# CORPORATION OF THE TOWNSHIP OF ESQUIMALT

APC Meeting: June 18, 2019

## STAFF REPORT

**SUBJECT: REZONING APPLICATION**  
**1048 Tillicum Road**  
**[Lot D, Section 10, Esquimalt District, Plan 11683]**

### B.C. Land Surveyor's Sketch Plan of:

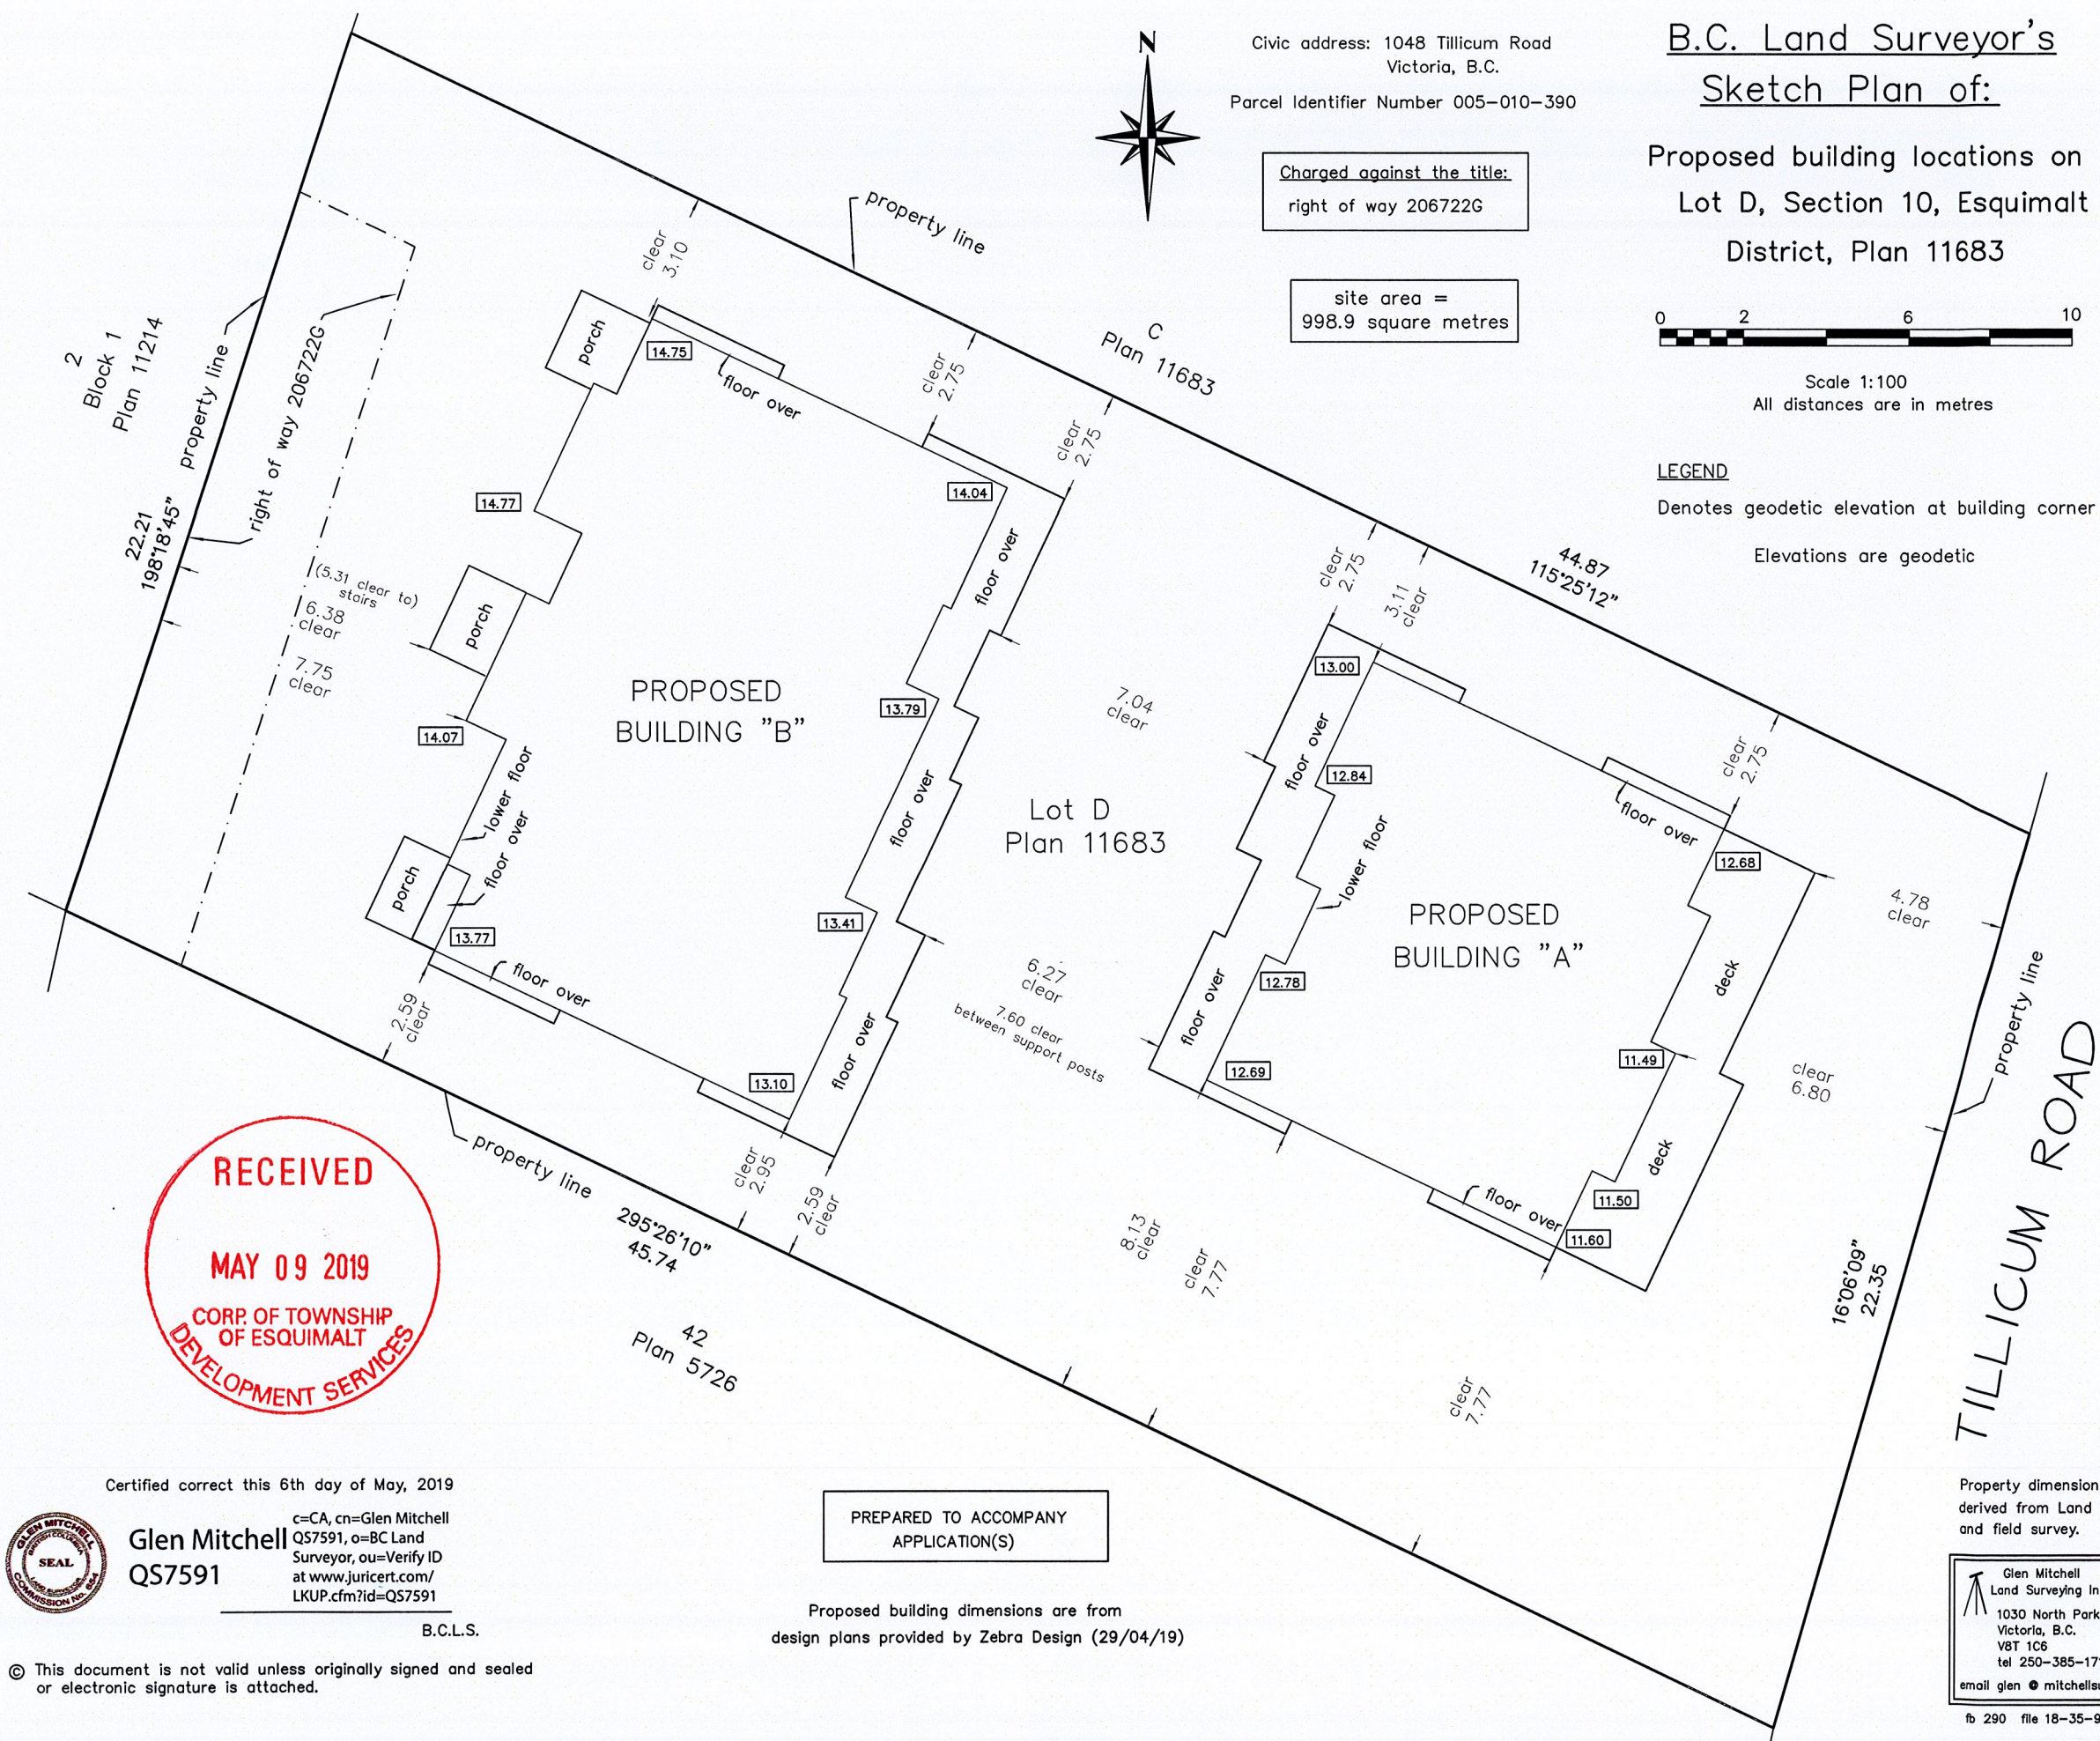
Staff notes the presence of a Statutory Right of Way [SRW] located abutting the rear property line of the parcel. Staff request the southern side yard design of Building 'B' be amended by removing the proposed stairs and retaining wall and grading this portion of the site from the visitor parking space up to the elevation to the proposed rear yard. This will ensure access to the SRW is preserved in perpetuity.
